## SUBHOI CY-27 TECH NOTES

**B7B-2**

During the construction of the Su-35/Su-37 Conversion Kit we discovered an error in the size of the inlet duct holes in bulkhead B7B-2.

**B7B-2**

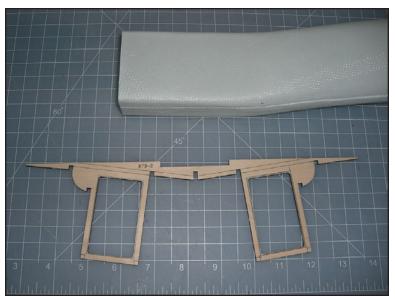
While this error can be corrected when fitting the inlets ducts to the model, it's easier to enlarge the holes before beginning construction.

□ 1. Cut from the sheet one bulkhead B7B-2. (1/8" lite ply) Pull the inlet ducts from the poly shipping bag. Using sandpaper, gently sand the forward opening of the inlet duct to remove any excess fiberglass. Repeat for the other side. (Photo 1)

☐ 2. Use a pencil and ruler to draw a line that is 1/64" outside the inlet duct opening in B7B-2. Repeat for the other side (Photo 2)

□ □ 3. Use a coping saw or a scroll saw to cut along the lines you drew earlier. Check the fit by inserting the inlet ducts into the opening.. Repeat for the other side. (Photo 3)
